COMMENTS OF THE DEPARTMENT OF ENERGY AND THE REGENTS OF THE UNIVERSITY OF CALIFORNIA ON DRAFT PERMIT NUMBER 0890010515-1 TO OPERATE HAZARDOUS WASTE FACILITIES, BEFORE THE NEW MEXICO ENVIRONMENTAL IMPROVEMENT DIVISION-JULY 18, 1989.

The Department of Energy and the Regents of the University of California respectfully request the Environmental Improvement Division's (EID) consideration of the following comments regarding draft permit number 0890010515 relating to the operation of hazardous waste facilities at Los Alamos National Laboratory (LANL):

FIGURE 6

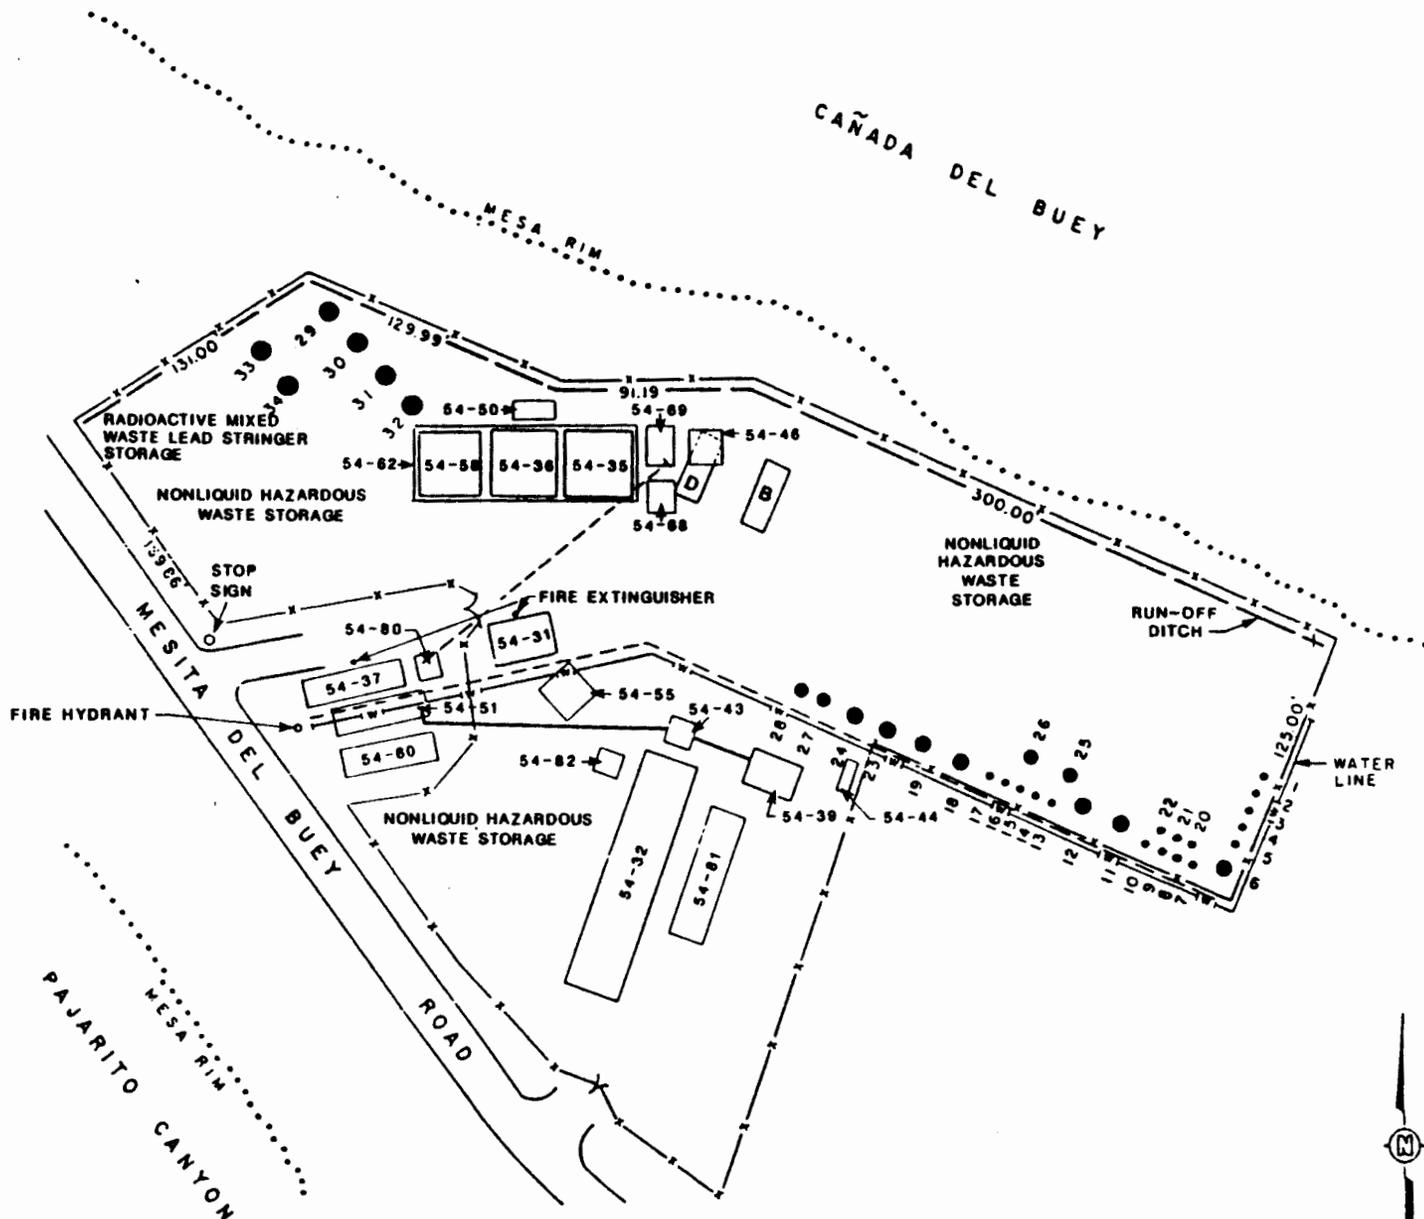
"Figure III-1" in each of these paragraphs should be "Figure 6".

Additionally, there appears to be an unnecessary and duplicative copy of Figure 4 after Figure 6 following the Modules. Attached (as Exhibit 1) to these comments is an updated version of Figure 6 relating to the location of waste management units at TA-54 Area L. The new Figure 6 should replace the outdated one found after the Modules and also the outdated ones found at:

- E.3.2
- E 7.2
- E.8.1
- E.9.1
